Watts Bar Nuclear Plant, Unit 2  
NRC Docket No. 50-391

**Subject: Watts Bar Nuclear Plant (WBN) Unit 2 – Safety Evaluation Report  
Supplement 22 (SSER22) - Response to NRC Required Action Items**

### Response to Action Items From Appendix HH of NUREG-0847, Supplement 22

FIGURE 2  
WATTS BAR UNIT 2, CYCLE 1  
CONTROL AND SHUTDOWN ROD LOCATIONS

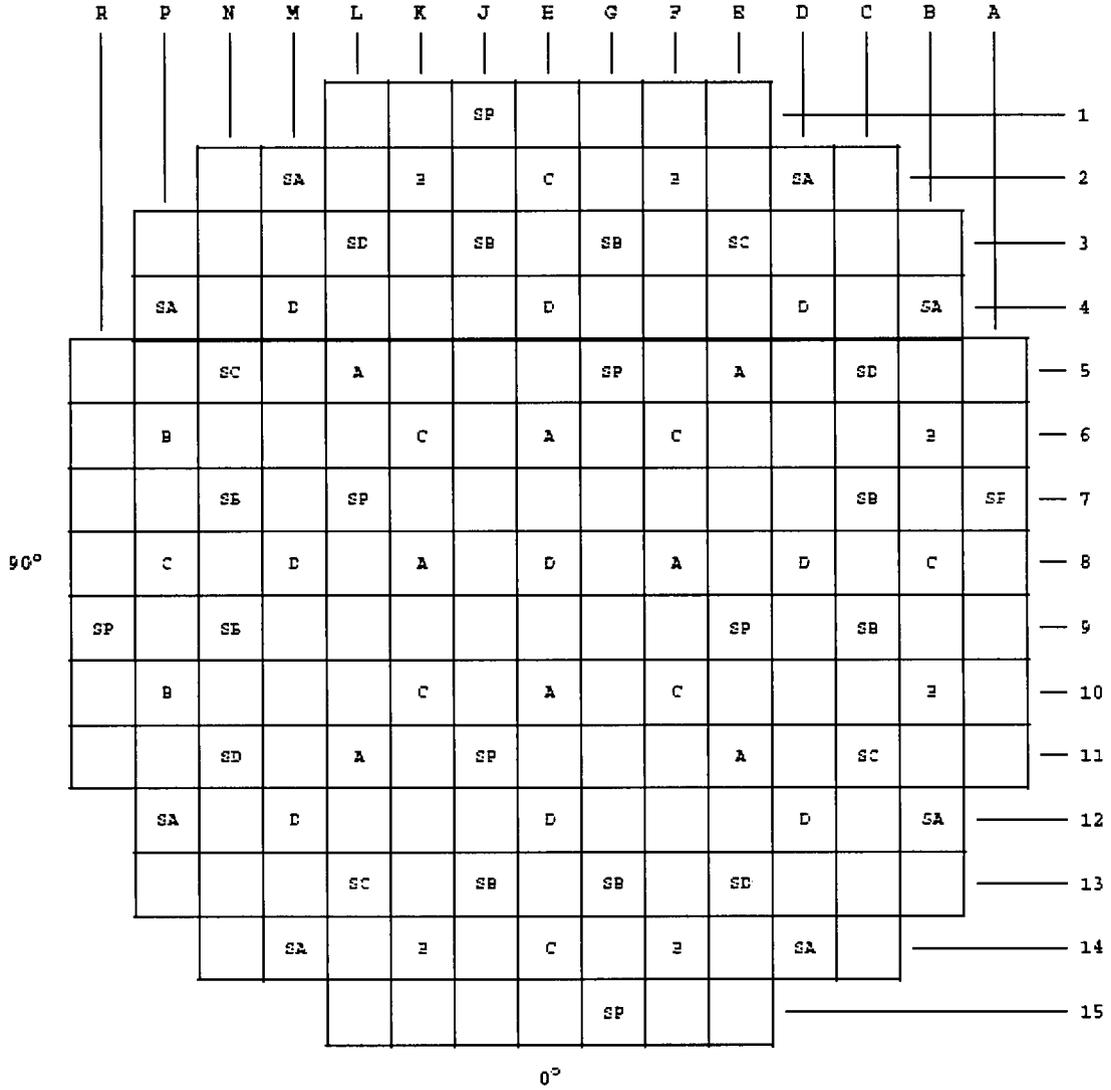
8. *Verify rod control system operability during power ascension. TVA should provide a pre-startup map to the NRC staff indicating the rodded fuel assemblies and a projected end of cycle burnup of each rodded assembly for the initial fuel cycle 6-months prior to fuel load. (NRC safety evaluation dated May 3, 2010, ADAMS Accession No. ML101200035)*

**Response:** Attachment 1 provides the requested pre-startup map indicating the rodded fuel assemblies and the projected end of cycle burnup of each rodded assembly for the initial fuel cycle.

Figure 1 provides the core loading pattern for WBT01, while Figure 2 provides the control and shutdown rod locations. Figure 3 provides assembly average burnups for all core locations, at the maximum analyzed Cycle 1 burnup (17675 MWD/MTU).
